AUDIO SERVICE

BULLETIN NO.: 05-84

SUBJECT: A-960 Amplifier

Tone control
cct. board

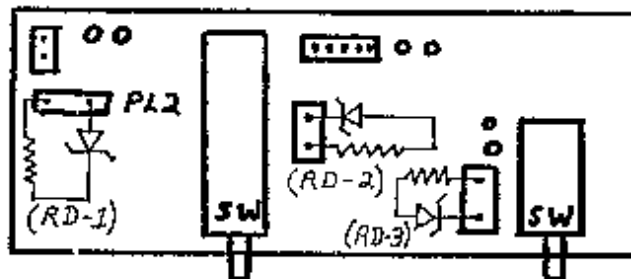
PROBLEM: Power won't come on, circuit checks out normal

CAUSE: Burnt out lamp in "Power" switch button, also in "Main Direct" or "Disc" button when switch is activated.

REMEDY: Replace burnt out lamp(s) and modify lamp circuit.

MODIFICATION: Solder a 22 ohm 1/4W resistor in series with a 10 volt 1 watt zener diode to connector pins shown on diagram as RD-1, RD-2, and RD-3.
